## **MEMORANDUM**

**Project Name:** Strawberry Farm Subdivision  
**Subject:** Site Visit No. 03  
**Date:** September 27, 2024  
**Time:** 3:00 PM  
**Location:** 95 Taylor Street, Littleton, MA  
**Weather:** Sunny, 75 degrees  
**Prepared by:** Shaharyar Khan  
**Attendees:** Mark Gallagher Sr., Seal Harbor Companies (MG)  
Shaharyar Khan, Green International Affiliates, Inc. (SK)

Photo 7 & 8 by MG:  
AD-3 installation.

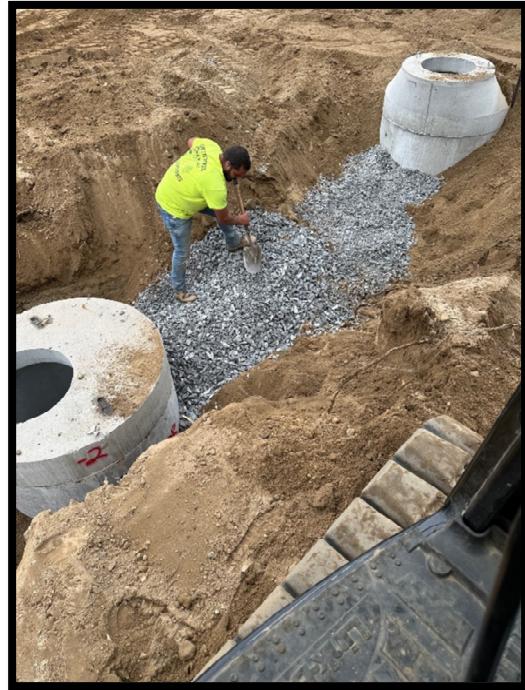
- All drainage structures (2- DMHs, & 3-ADs) also had been installed. MG agreed to share the photos of the installation of these structures since the trenches had already been backfilled before the scheduled the site visit.

- Please see photos (7-11) received from MG for the drainage structures installed.
- Subgrade had been prepared for the roadway. The subgrade material was observed and is adequate.
